CERTIFICATE OF APPROPRIATENESS PLACARD

PRINCE HALL

Minor Work Application

Gorham House 420 S. Bloodworth St.

A5

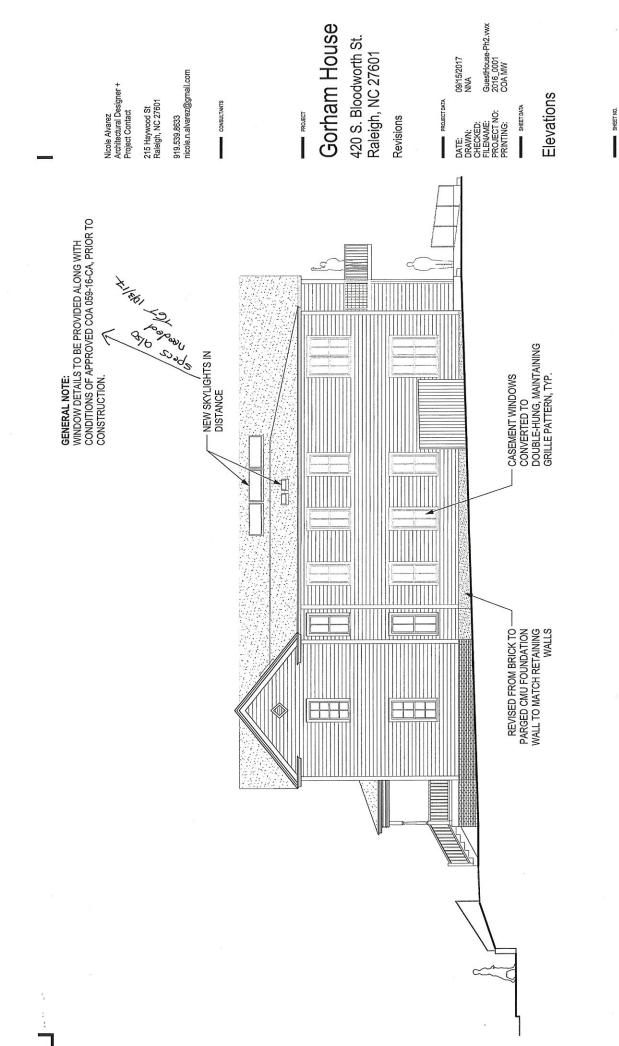
Elevations PROJECT DATA CONSULTANTS DATE: DRAWN: CHECKED: FILENAME: PROJECT NO: PRINTING: SHEET DATA SHEET NO. PROJECT Revisions REVISE PREVIOUSLY APPROVED BRICK-RETAINING WALL: TO BE PARGED CMU TO MATCH NEIGHBOR. LOWER MAX HEIGHT FROM 42" TO 32" REVISED FROM BRICK TO — PARGED CMU FOUNDATION WALL TO MATCH RETAINING WALLS CASEMENT WINDOWS —
CONVERTED TO
DOUBLE-HUNG, MAINTAINING
GRILLE PATTERN, TYP. KITCHEN WINDOWS SLIGHTLY SHORTER
